**ZONING MAP CHANGE
STAFF REPORT**

Site Location: 5400 & 5420 E. Rosedale Street Mapsco: 79L

Request: From: "E" Neighborhood Commercial
To: "PD/D" Planned Development for all uses in "D" High Density Multifamily with waivers and urban development standards, site plan included.

ZC-16-094

ARCHITECTURAL SITE PLAN, 5.09 ACRE SITE
April 21, 2016

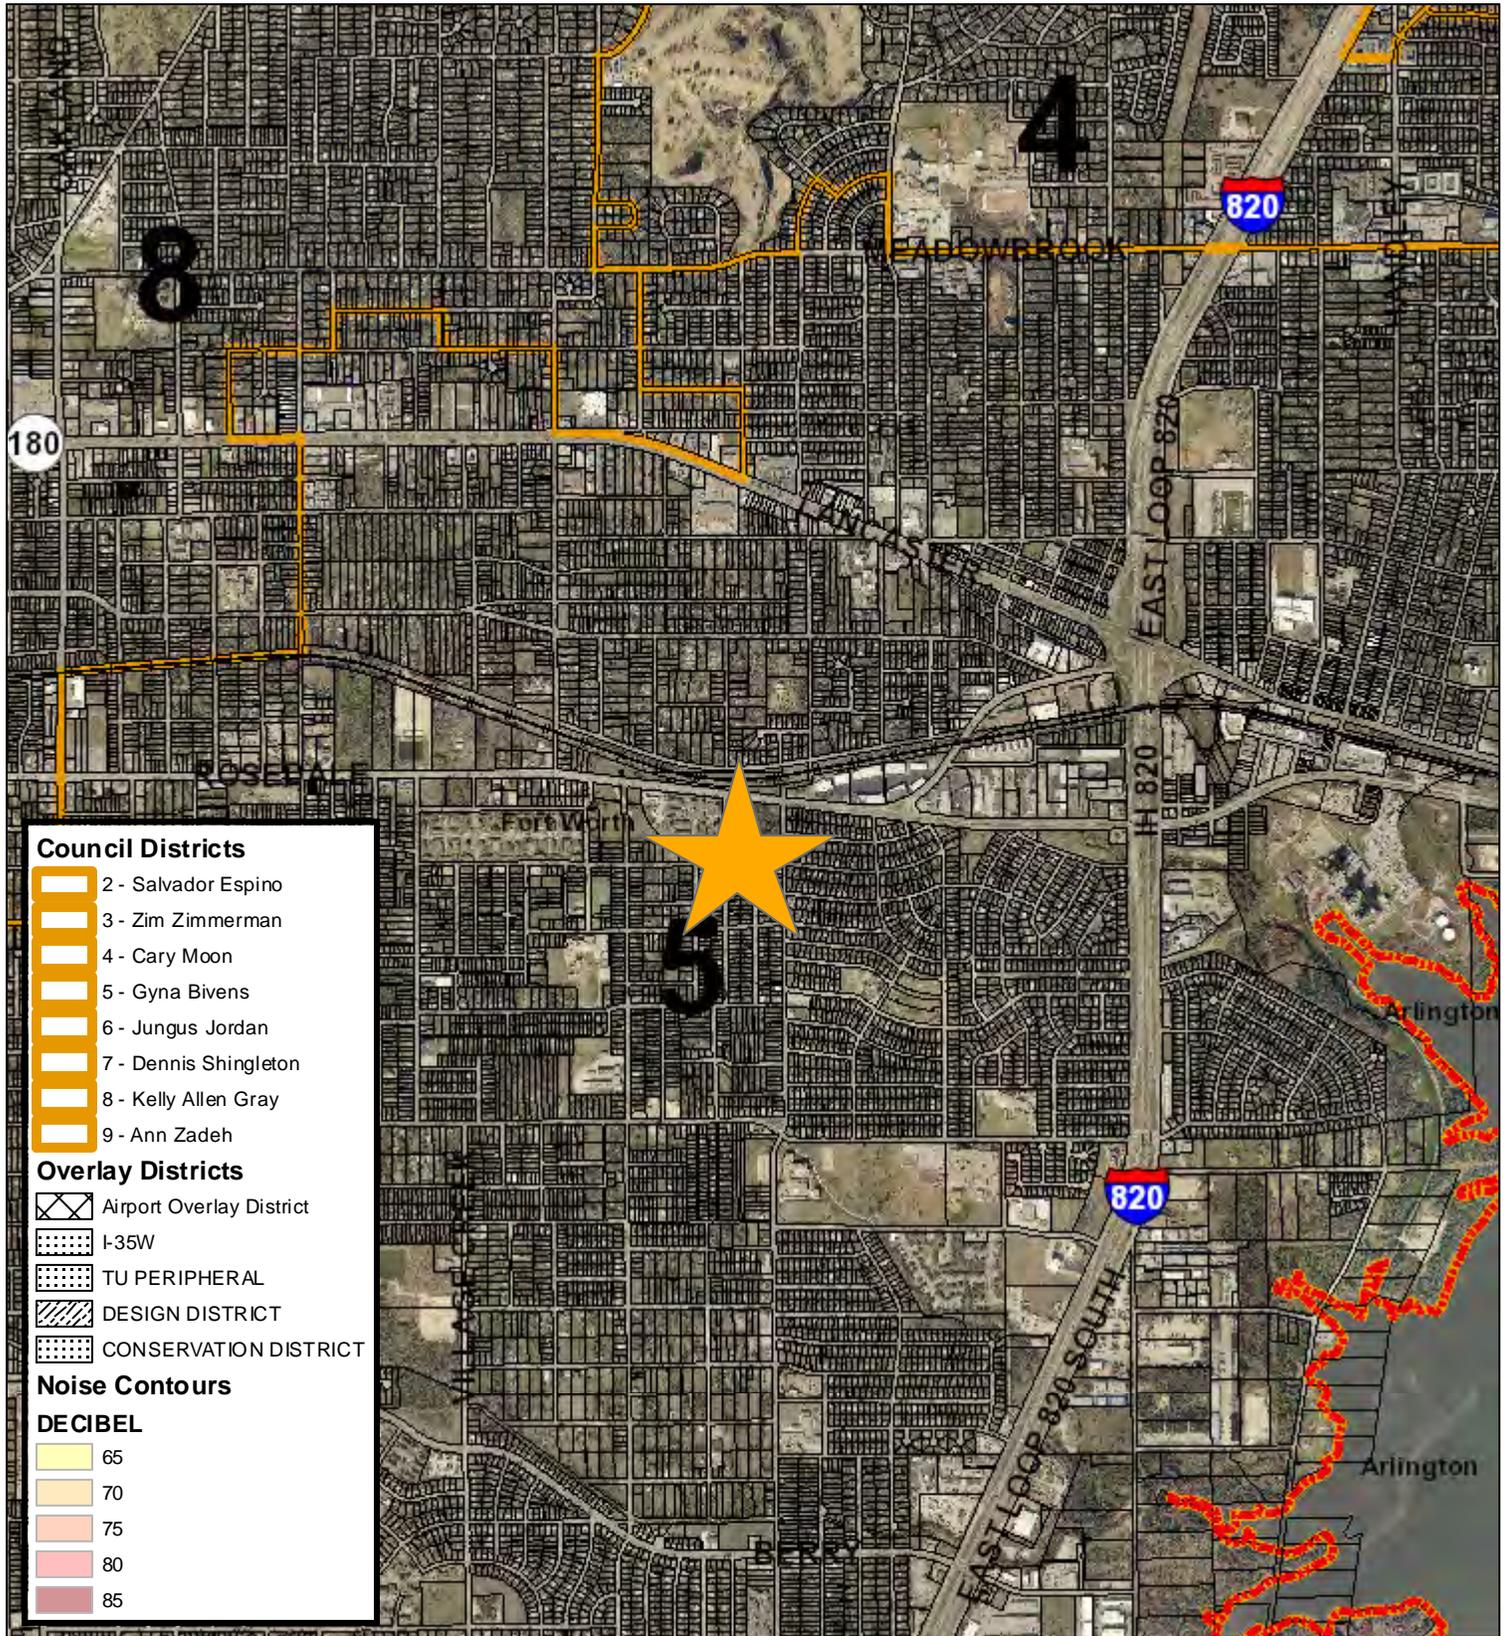
The site plan as submitted is in general compliance with the zoning regulations.

1. 20 ft. setback along Andrew Ave and Kutman Ct (**waiver requested**).
2. Roughly 26 units per acre (**waiver requested (24 units per acre in D)**)

2. Gated entrances into secured areas must be designed in accordance with TPW's "Traffic Engineering Design Standards and Policy Guidelines". Provisions for an acceptable turnaround must be made. Provide details in IPRC plan set (single-family) or UR site plan (multi-family) for gates. All gates shall be equipped with a Knox-box or other approved fire access apparatus that is reviewed and approved by the Fire Department. (Gates must be located 3 vehicle lengths from the ROW). The proposed gate on Rosedale does not comply with TPW stacking requirements.

4. TXDOT permit is required for work in and along State ROW. Street connections to TXDOT ROW is contingent upon TXDOT approval. TXDOT approval required for any proposed interchanges and/or driveway access to TXDOT facilities. The proposed driveway location on Rosedale will require an access permit from TXDOT. As this access is not guaranteed, it is recommended that the access be provided from Andrew or Kutman as two access points are required based on the number of units.

1. All gates shall comply with Section 503.6 of the CFW Fire Code.
2. Show dimension of fire lane near each building. A minimum of 26' wide fire lane is required for all multifamily buildings.
